<b>OFFICE OF ENVIRONMENTAL SUSTAINABILITY</b>
<b>REPORT OF THE TECHNICAL COMMITTEE ON REPRESENTATIONS MADE ON A DRAFT CERTIFICATE OF AUTHORISATION</b>	
<b>TO:</b>	Board of Directors
<b>FROM:</b>	Technical Committee Circular Economy Programme
<b>DATE:</b>	10th of March 2022
<b>RE:</b>	Representation on draft Certificate of Authorisation issued to <b>Fingal County Council</b> for a closed landfill at Barnageeragh Cove, Skerries, County Dublin. Certificate of Authorisation Register Number <b>H0167-01</b> .
<b>APPLICATION DETAILS</b>	
Type of facility:	Closed landfill as defined in the Regulations <sup>1</sup> .
Application received:	28 August 2020
Draft Certificate issued:	15 April 2021
First party representation received:	14 May 2021

## 1. Background to this report

**Appendix 1: Site Map Showing Waste Areas**

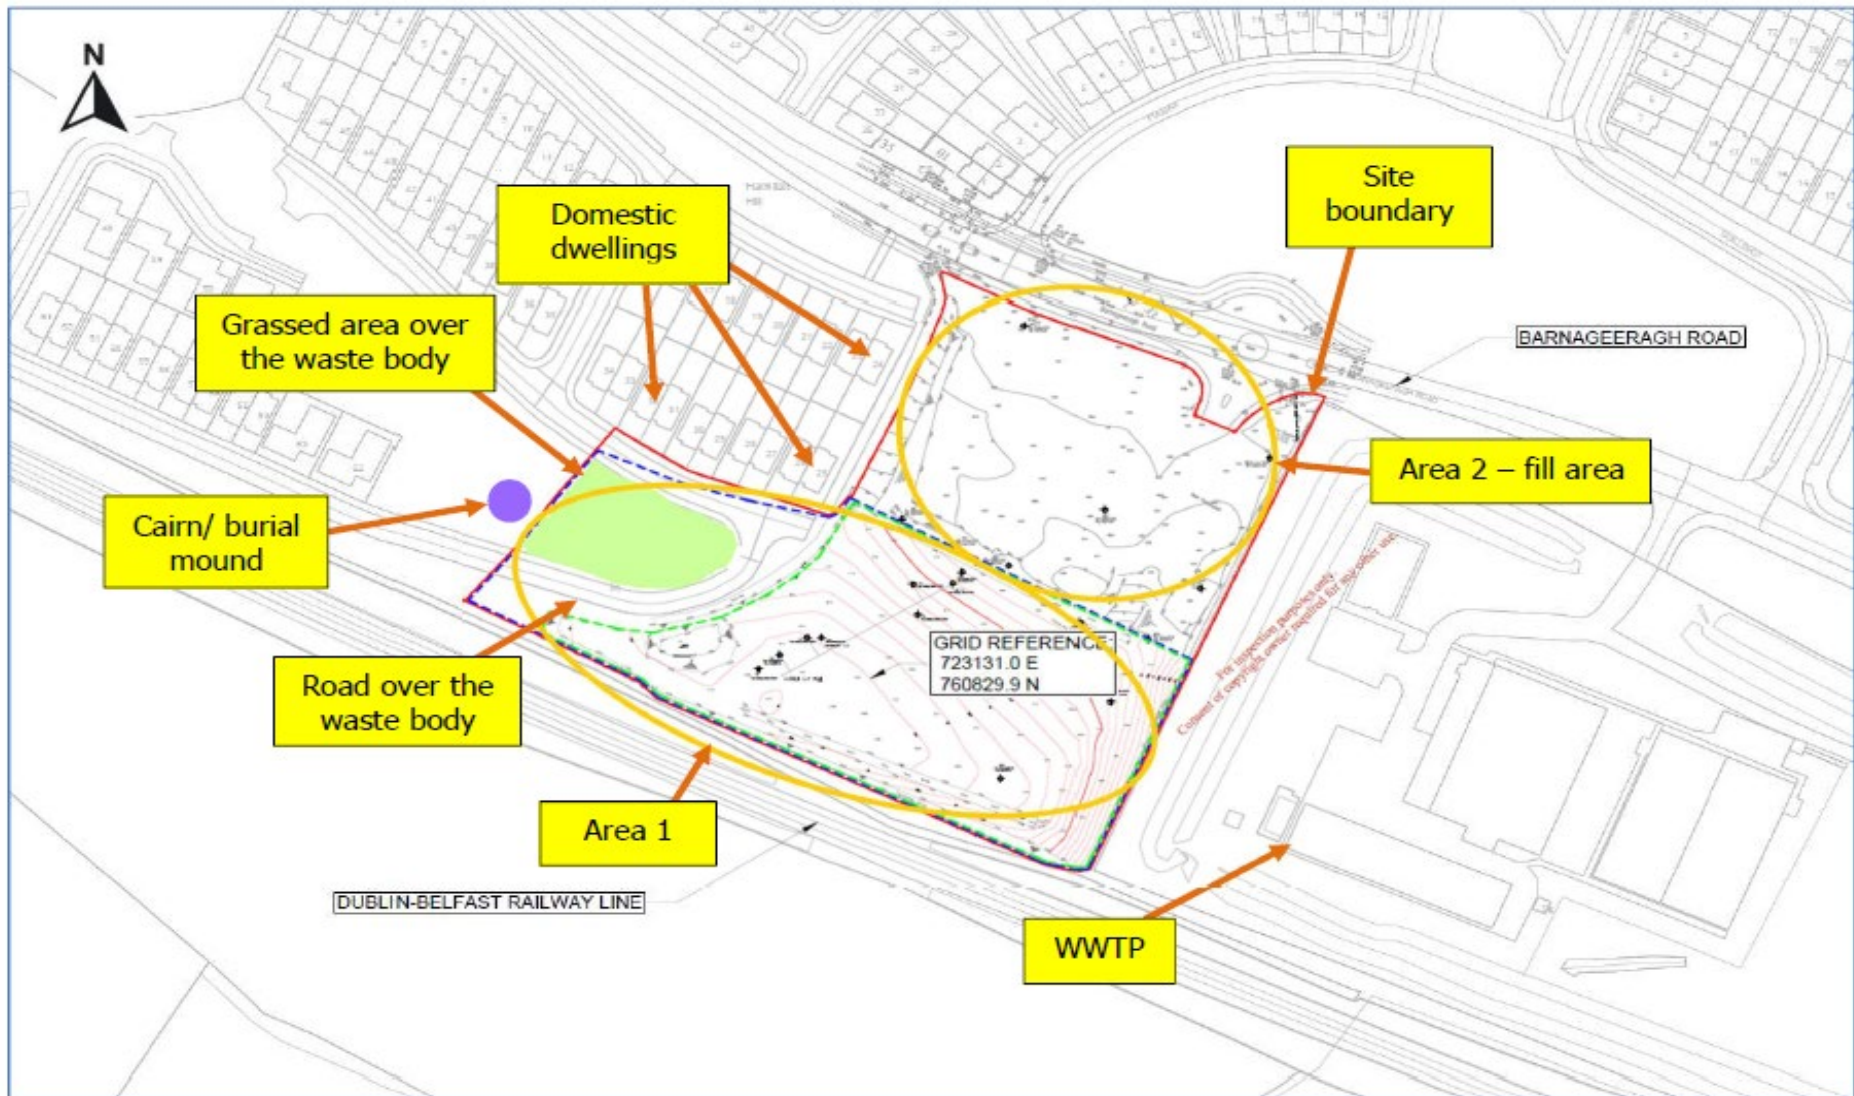
The applicant requests that the requirement to install a cap over the grassed area of Area 1, in front of the adjacent houses numbered 27 – 32, is removed from the CoA. Refer to Appendix 1 for Site Map. The applicant considers that a cap for this area of the site is not a sustainable solution given the age of the waste and the environmental risks. Alternatively, if this request is not acceptable to the Agency, the applicant requests a reduced thickness of soil (subsoil and topsoil) of 0.5m in order to limit the depth of excavation required and the potential to cause significant disturbance to a national monument located in the grassed area.

- Waste within the grassed area of Area 1, as shown in Appendix 1, consists of a mix of C&D and municipal waste. Hazardous waste (identified as soil & stone containing hazardous substances) was also found in trial pits in the grassed area.

In relation to the hazardous waste found within the grassed area, the Tier 2 and Tier 3 Assessment Report states that "the green area and the pavement provide an effective barrier to dermal contact and rainfall infiltration". However, in relation to rainfall infiltration, the TC considers that this can only be demonstrated effectively through monitoring the impact to groundwater within the area. In this context, the TC notes that groundwater borehole BH2, as per Appendix 2, is located at the edge of the grassed area and represents an upgradient borehole for the area and overall site. The nearest downgradient boreholes to BH2, are BH1 and BH3. However, these boreholes are located within the main waste body of Area 1 and cannot provide a downgradient representation of groundwater for the grassed area alone.

Taking account of the aspects noted above and the difficulties that capping may present in relation to the national monument, the TC recommends that an additional groundwater monitoring borehole is installed in the grassed area to assess the impact of the deposited waste on groundwater from this specific area. The borehole should be positioned downgradient of BH2 and in an optimum location to monitor groundwater from the area of maximum waste depth within the grassed area, as shown in drawing number MGE0755-RPS-01-XX-DR-C-DG0004. It is recommended that capping is carried out unless the applicant can demonstrate to the Agency that groundwater beneath the grassed area is not being impacted by the deposited waste, following groundwater monitoring for a period of 12 months. If required, the appropriate capping can then be determined in accordance with the EPA Landfill Manuals and a proposal submitted to the Agency for approval prior to installation.

3.1(b) **(i)** Install a low permeability landfill cap, minimum 1m, with 1mm thick low permeability geomembrane having a hydraulic conductivity of less than or equal to  $1 \times 10^{-9} \text{m/s}$ ; The landfill cap shall be installed over the waste body, as shown on Drawing No. MGE0755-RPS-00-XX-DR-C-DG0001-02 (Revision F01 dated 13/11/20) titled 'Barnageeragh historical landfill site location map - contour map'.

**(ii) Groundwater monitoring should be carried out on a monthly basis from the existing monitoring borehole BH2 and a new borehole, installed within the grassed area and downgradient of BH2, for the parameters required under Condition 3.9(e). Following groundwater monitoring for a period of twelve months, and assessment of results, install an appropriate landfill cap over the grassed area opposite Houses No. 27 to No. 32, in accordance with the Agency's Landfill Manuals "Landfill Restoration and Aftercare", unless otherwise agreed by the Agency. Proposals on the design of the cap shall be submitted to the Agency for approval prior to installation.**
